Addendum #1

Date: April 27, 2015
Project: Warren Franklin East Window Replacement
Contract: FD-14-098

DATE: 3-23-2015 DRAWING NUMBER: A10-03

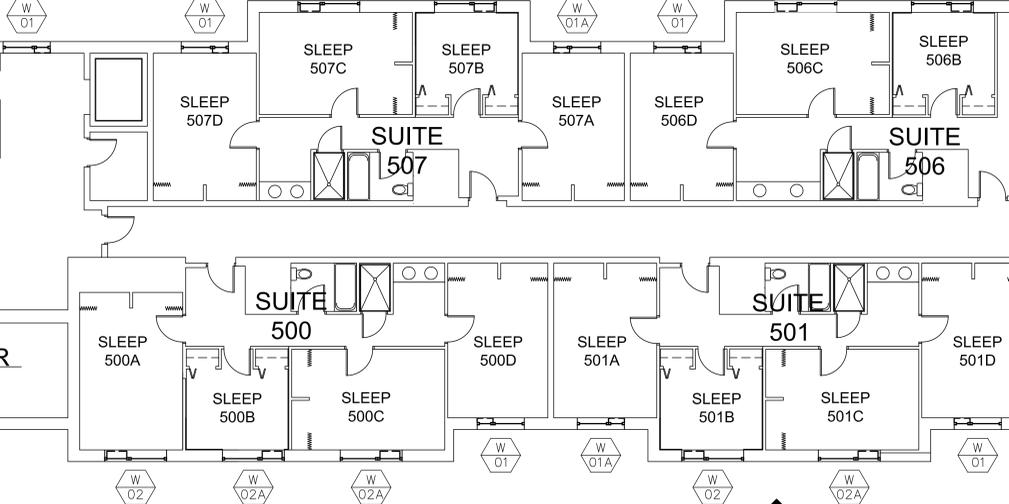
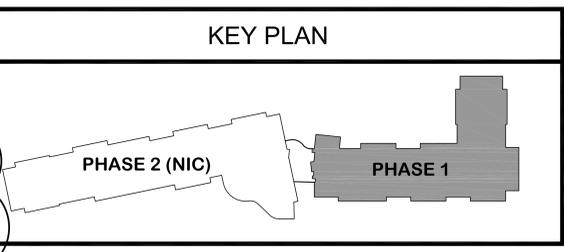
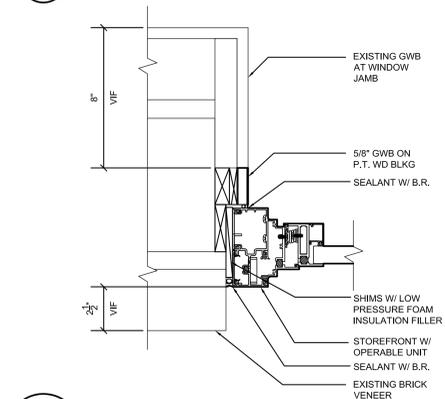
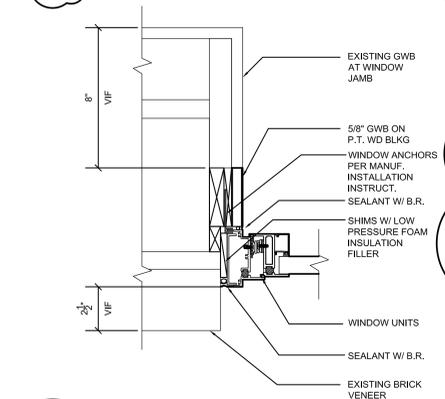
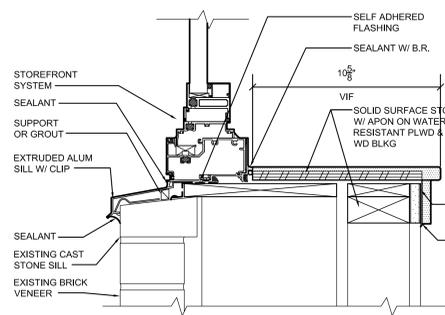
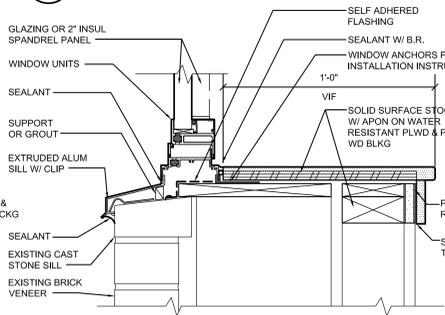
1. Section T10-02 reissued. Revised Storefront/ Window Spec & added Window Treatment Spec.
2. AD10-02 reissued. Annotations and notes have been added.
3. AD10-03 reissued. Annotations and notes have been added.
4. Section A10-03 reissued. Added 2 details, renumbered details, added detail marks to elevations.
